TOTAL PERFORMANCE
VAN'S AIRCRAFT

NOTIFICATION 14-05-22

Subject: Canopy Latch Warning

Affected Models: All RV-12 SkyView or G3X Touch equipped aircraft.

FIGURE 1: ADDING THE LATCH PLATE

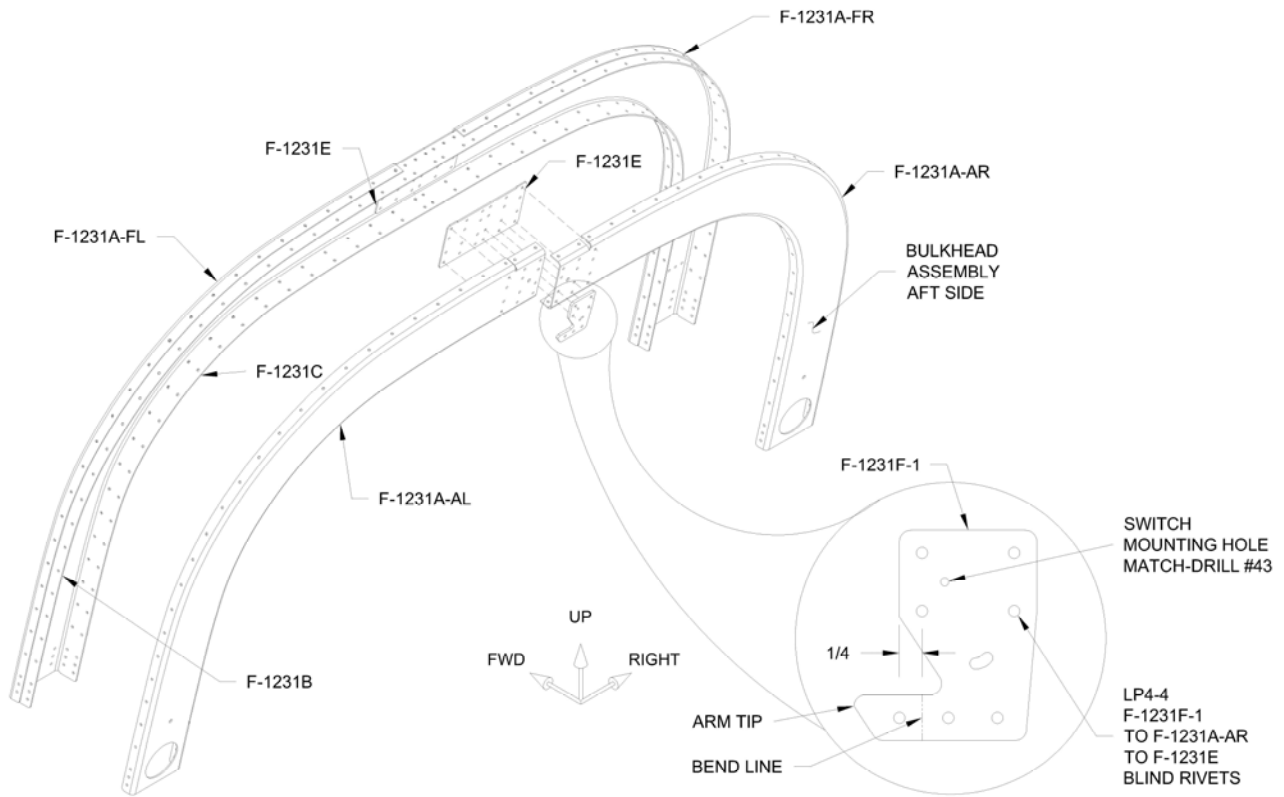
Step 12: Cleco the F-1231F-1 Latch Plate to the F-1231A-AR Roll Bar Frame and aft F-1231E Splice Plate. Match-Drill #43 a hole in the roll bar frame and splice plate using the switch mounting hole as a guide. See the detail view in Figure 1.

Step 15: Curve the arm of the F-1231F-1 Latch Plate forward starting at the bend line shown in the detail view in Figure 1 until a 1/8 inch gap exists between the tip of the arm and a flat surface.

Step 16: Close the canopy and latch it shut. The flat portion of the WD-1218 Canopy Latch should slide down the ramp of the C-1205-1 Latch Block. There should be little or no friction between the canopy latch and the F-1231F-1 Latch Plate arm. See Figure 1.

Step 18: Rivet the F-1231F-1 Latch Plate to the F-1231A-AR Roll Bar Frame and aft F-1231E Splice Plate as shown in the detail view in Figure 1.

FIGURE 2: REPLACING THE LATCH BLOCK

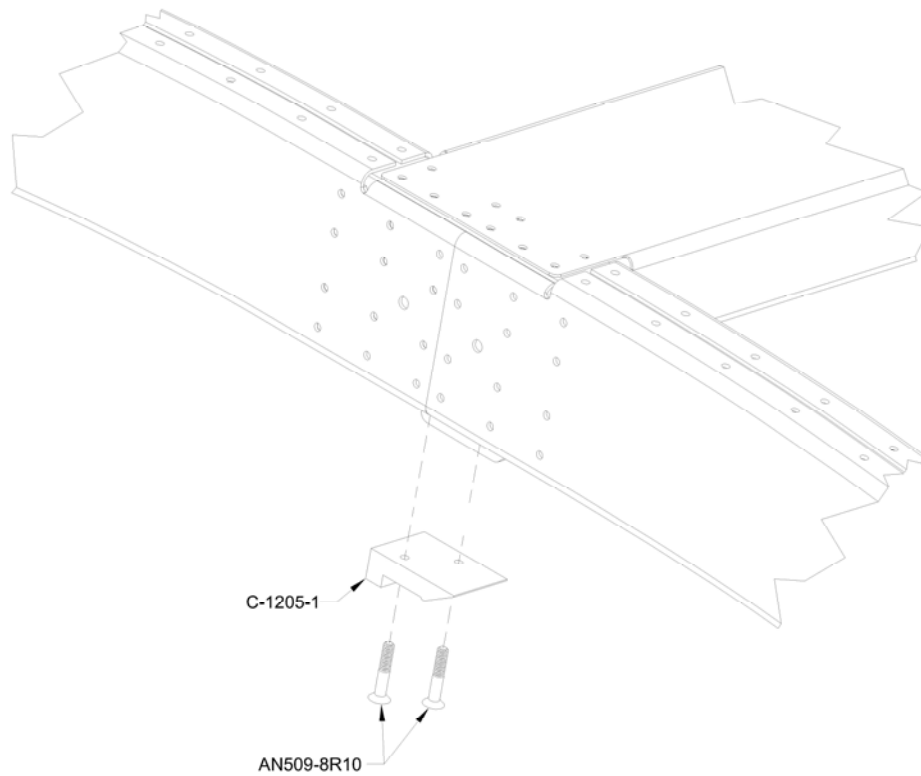
Step 10: Machine countersink the C-1205-1 Latch Block in two places to fit the head of a #8 screw. Slightly too deep is preferable to any protrusion of the screw head. See Figure 2.

Screw the latch block to the roll bar using the hardware called out in Figure 2.

Step 24: Install the ring terminal end of the WH-W1115 (WHT) Canopy Latch Switch Ground Wire on the inboard side of the roll bar brace as shown in Figure 2.

FIGURE 3: WIRE ROUTING
(AFT RIGHT PORTION OF ROLL BAR NOT SHOWN FOR CLARITY)

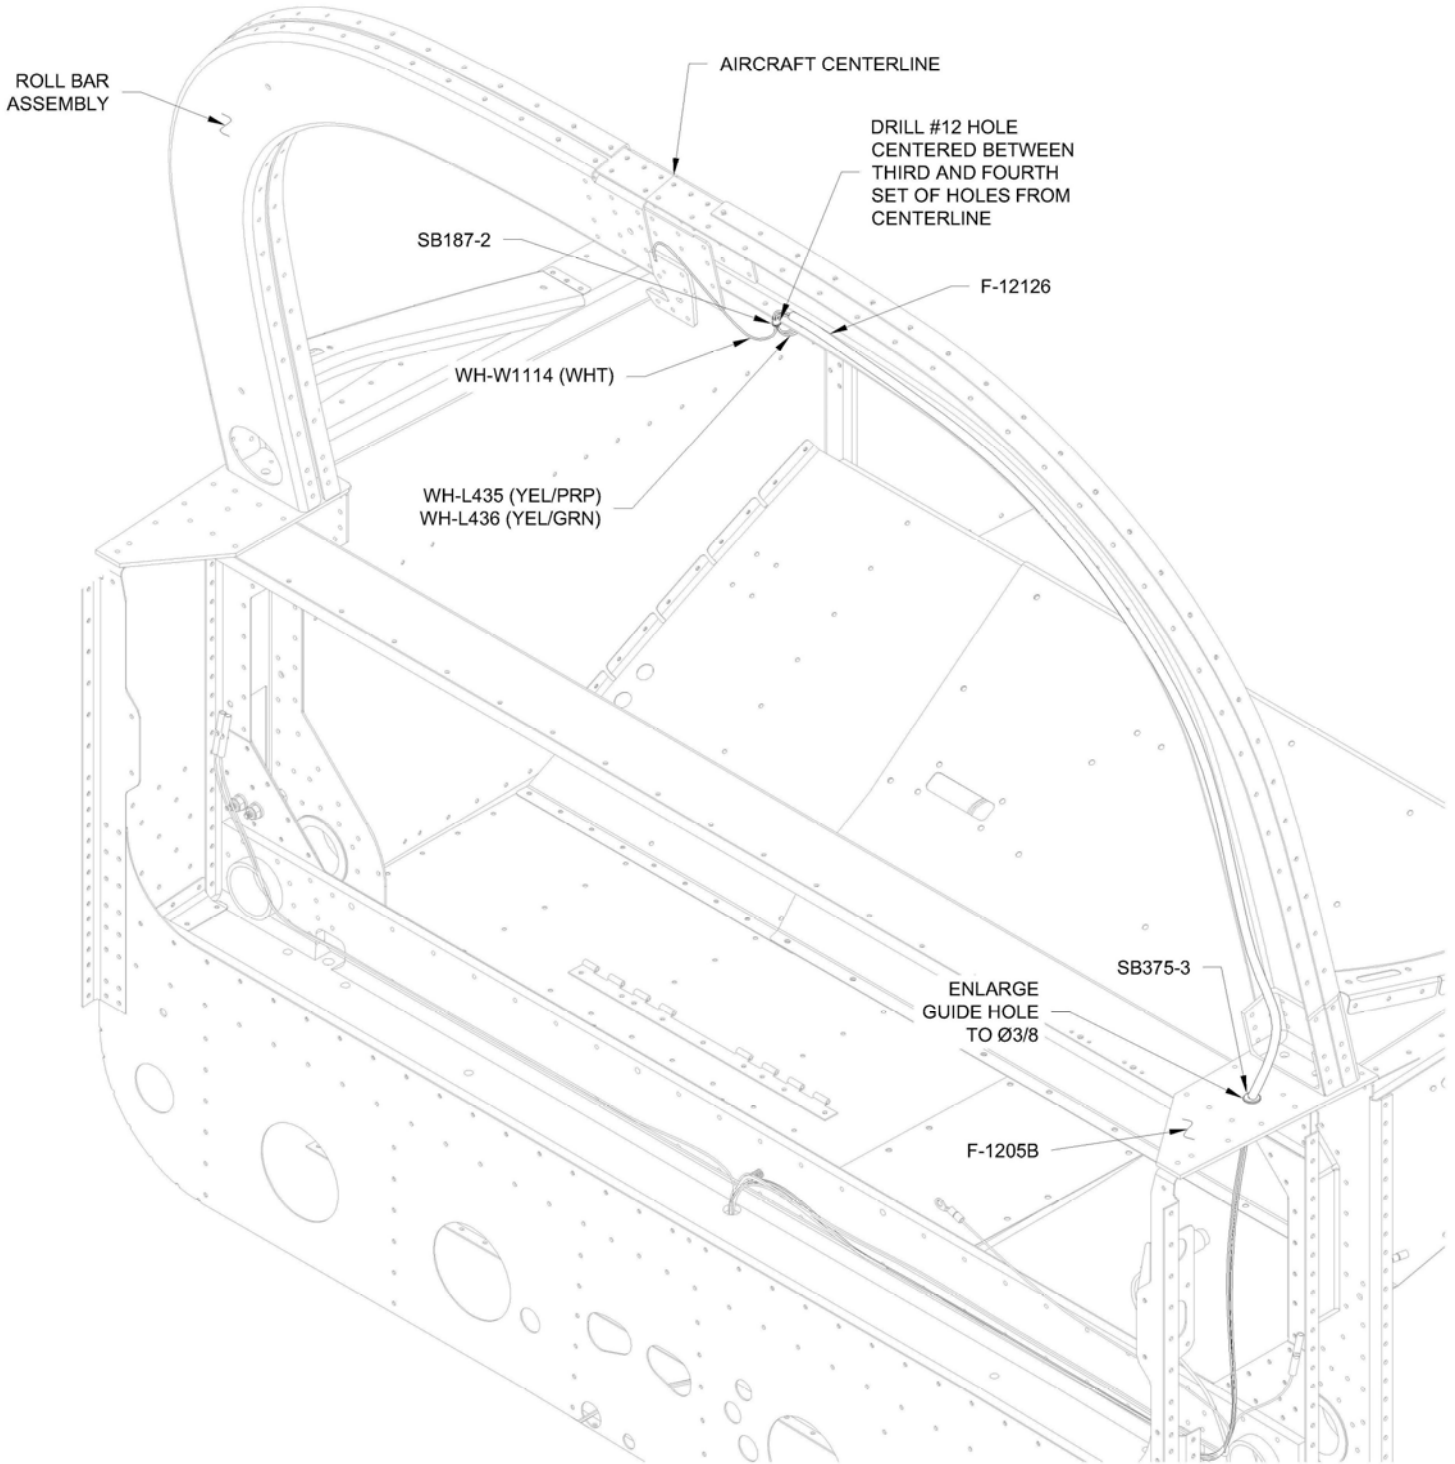
Step 6: Route the WH-00109 wire (WHT) through the snap bushing in the F-1205B Roll Bar Attach Plate as shown in Figure 3.

Step 7: Remove the snap bushing installed in the bottom center of the roll bar for the WH-L435 (YEL/PRP) Cockpit Light Power Wire and WH-L436 (YEL/GRN) Cockpit Ground Wire. See Figure 3.

FIGURE 4: SWITCH INSTALLATION

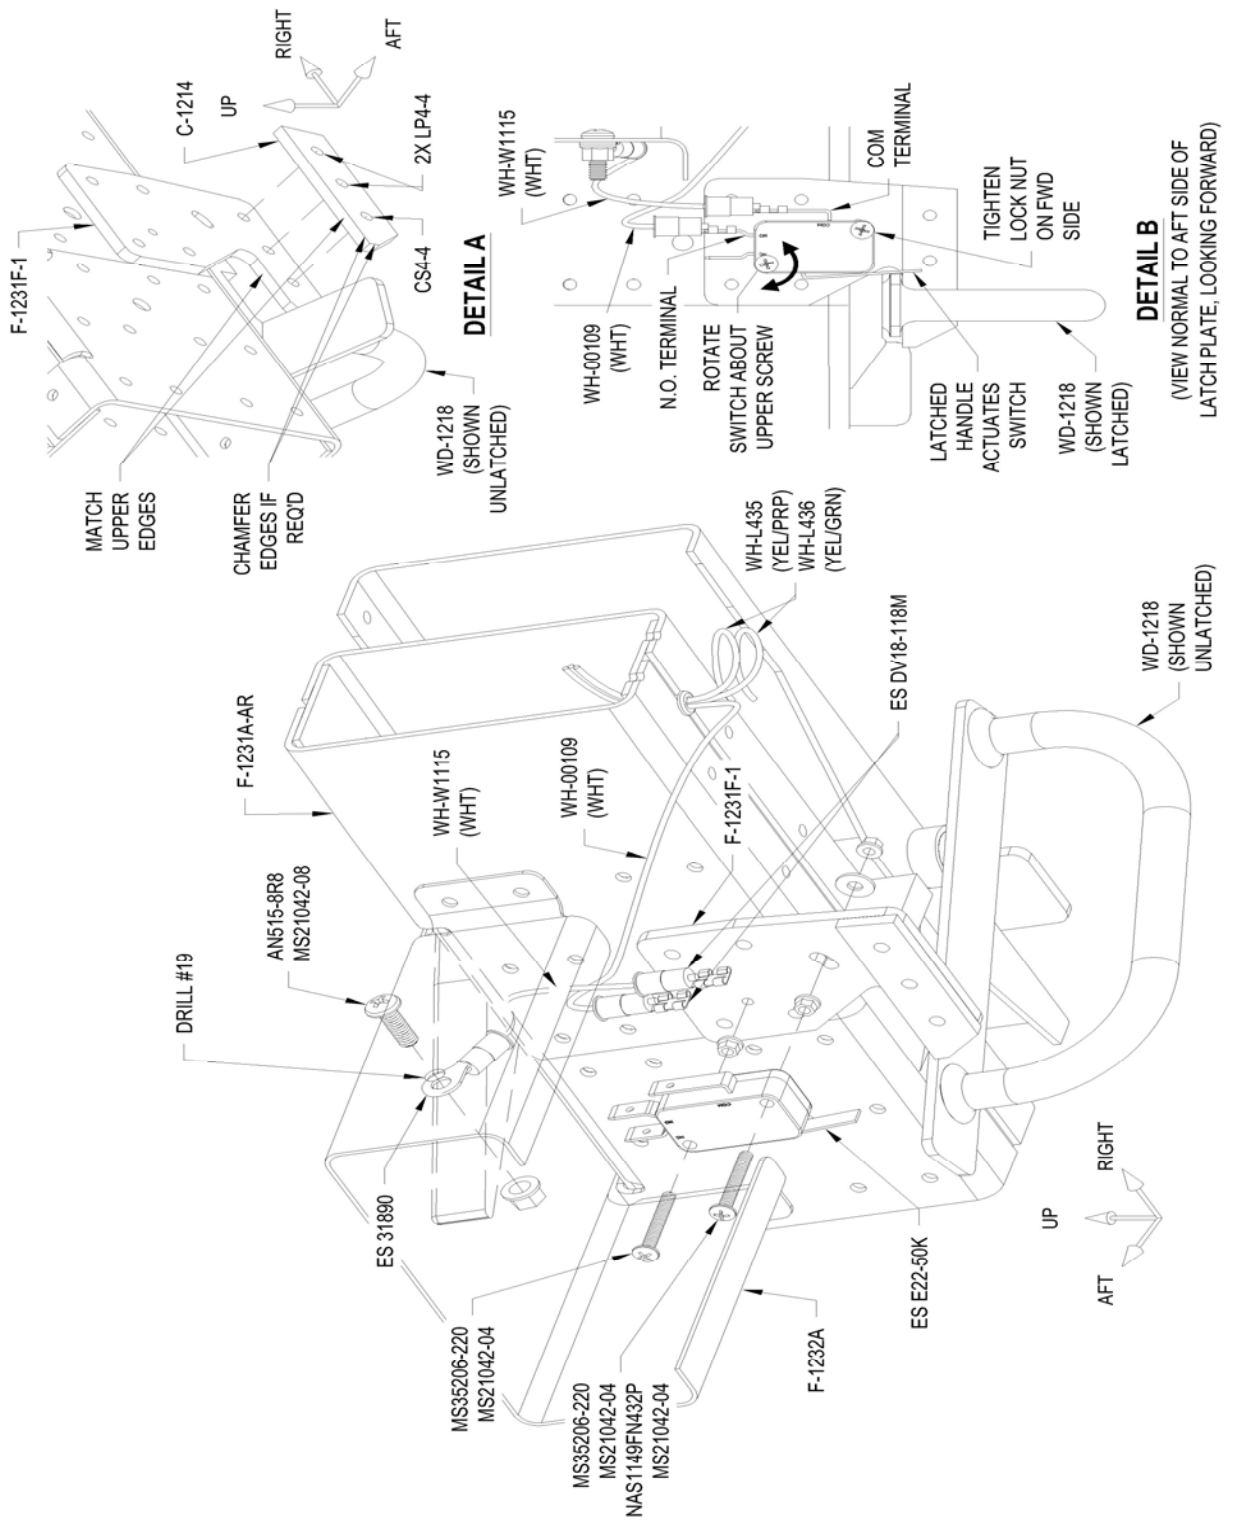
Step 8: Cut a 5" piece from the end of the WH-00109 wire. This will be used in Step 21. Crimp a female spade connector onto the WH-00109 wire (WHT). See Figure 4.

Step 17: Fabricate the C-1214 Latch Block from PS UHMW-125X1/2X2 by match-drilling three #30 holes using the F-1231F-1 Latch Plate arm as a drill guide. Countersink the leftmost hole so that the head of a CS4-4 Blind Rivet will be below flush. Trim the ends of the latch block to match the shape of the latch plate. Blind rivet the latch block to the latch plate as shown in Detail A in Figure 4.

The latch block will need to be chamfered to facilitate latching of the WD-1218 Canopy Latch. See Figure 4, Detail A.

Step 19: Remove/cut the roller from the end of the ES E22-50K Micro Switch arm but leave the switch arm as long as possible. Install the ES E22-50K Micro Switch on the F-1231F-1 Latch Plate as shown in Figure 4. Insert the screws into the micro switch mounting holes and thread on the two lock nuts. Orient the lock nuts so that the flanges will contact the latch plate. **DO NOT** apply more than 3 in.-lb beyond prevailing torque to the two lock nuts against the switch.

Secure the micro switch by tightening the lock nut against the washer on the forward side of the F-1231F-1 Latch Plate. See Figure 4, Detail B.

Step 21: Fabricate the WH-W1115 (WHT) Canopy Latch Switch Ground Wire using the wire cut in Step 8. Strip both ends of the ground wire. Crimp a female spade connector to one end of the ground wire. Crimp a ring terminal to the other end of the ground wire. See Figure 4.

Step 22: Connect the spade connector end of the WH-00109 (WHT) Canopy Latch Switch Terminal Wire to the N.O. (normally open) terminal of the ES E22-50K Micro Switch. See Figure 4, Detail B.

Connect the spade terminal end of the WH-W1115 (WHT) Canopy Latch Switch Ground Wire to the COM (common/ground) terminal of the micro switch. See Figure 4, Detail B.
